SERVICE BULLETIN

ENGINE - FUEL AND CONTROL - TO PROVIDE A NEW A1SCN13/Q ELECTRONIC ENGINE CONTROL (EEC)
SOFTWARE - CATEGORY CODE 4 - MOD.ENG-73-0112

ENGINE FUEL AND CONTROL - EEC150-20 - ELECTRONIC ENGINE CONTROL - INCORPORATION OF NEW SOFTWARE: A1 SCN13

Location of the Electronic Engine Control (EEC)
Fig.1

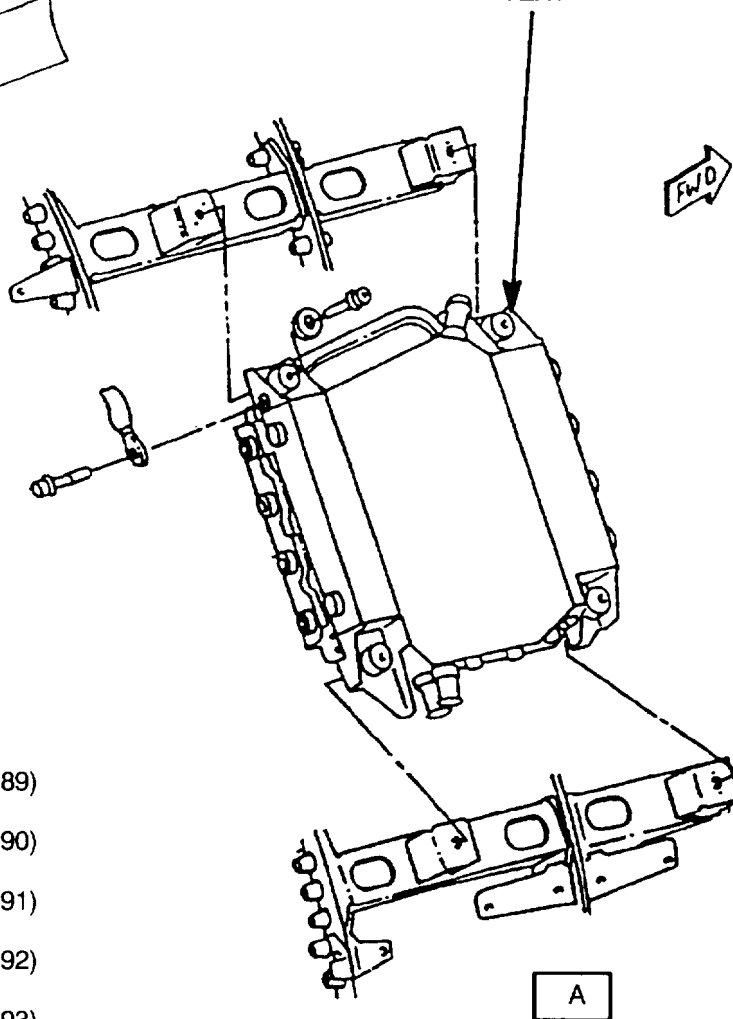
- (1) Remove the 808050-04-048 (2A3224), 798300-15-048 (2A3225), 798300-16-048 (2A3226), 798300-17-048 (2A3227) or 798300-18-048 (2A3228) Electronic Engine Control by the procedure given in Reference (4), Chapter/Section 73-22-34, Removal/Installation. Refer to Figure 1.

Procedure	Supplementary Information
(a) Send the Electronic Engine Control to the approved vendor to be modified. See Paragraph 2.B.	See Figure 1.
(2) Remove the Active Clearance Control (ACC) Front Duct Cover Assembly. Refer to V2500-ENG-75-0025 specified in Reference (1), and Figure 2.	
(a) Locate the Front ACC Duct.	
(b) Remove the two 4W0102 Bolts from the Front Duct Cover Assembly.	
(c) Remove the 2A3637 Front Duct Cover Assembly.

REMOVE THE ELECTRONIC ENGINE
CONTROL AND INSTALL THE NEW
ELECTRONIC ENGINE CONTROL
(EEC) OR OBTAIN THE NEW EEC BY
THE INSTRUCTIONS GIVEN IN THE
TEXT

***NEW PART NUMBER**

808050-04-050 (2A3289)
OR
798300-15-050 (2A3290)
OR
798300-16-050 (2A3291)
OR
798300-17-050 (2A3292)
OR
798300-18-050 (2A3293)

Location of the ACC Front Duct Cover Assembly
Fig.2

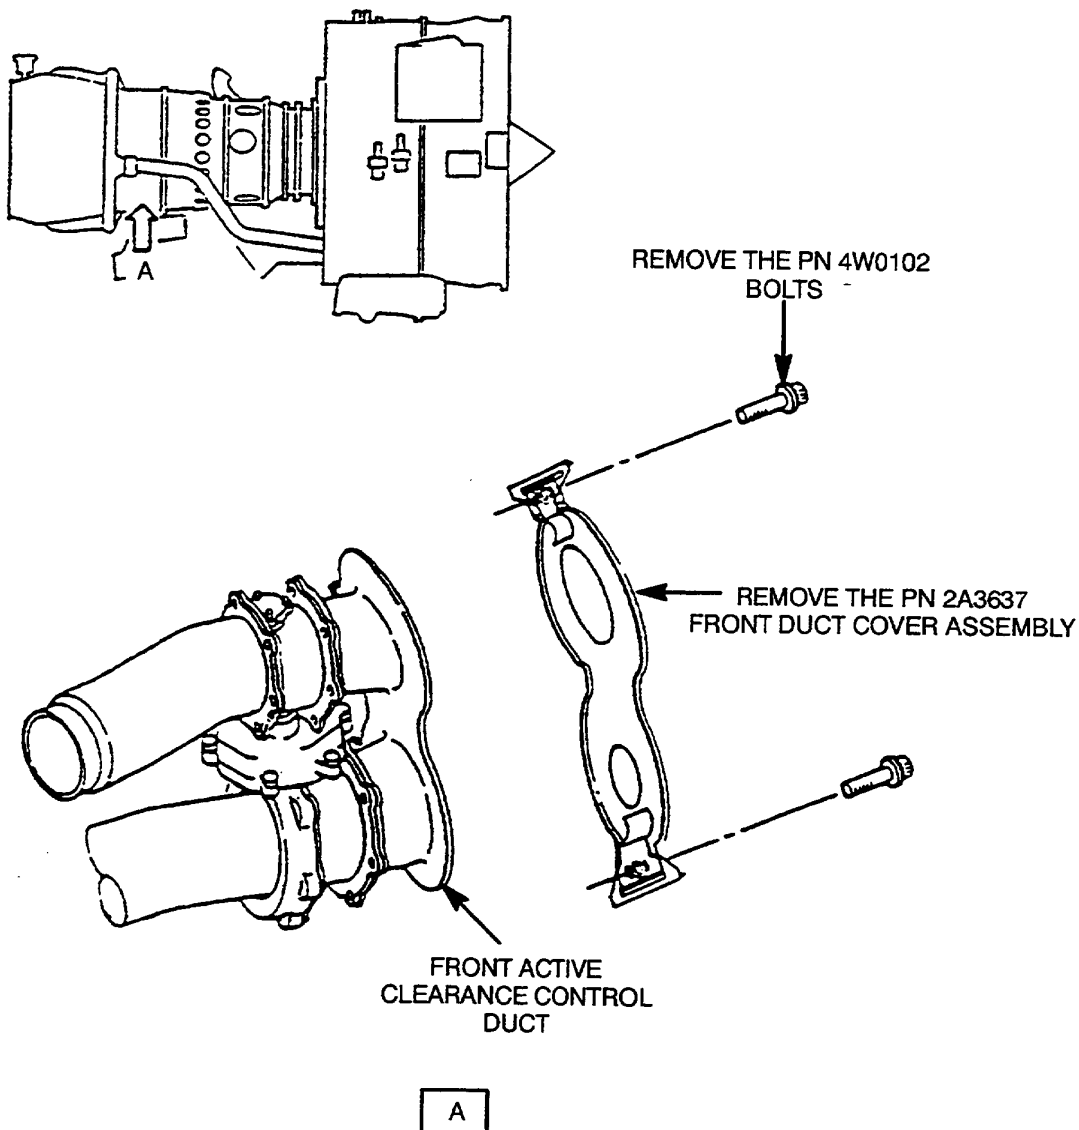
NOTE: When you incorporate this Service Bulletin with the new SCN13/Q software logic, the Front Duct Cover Assembly given in V2500-ENG-75-0025 must be removed. See Reference (1).
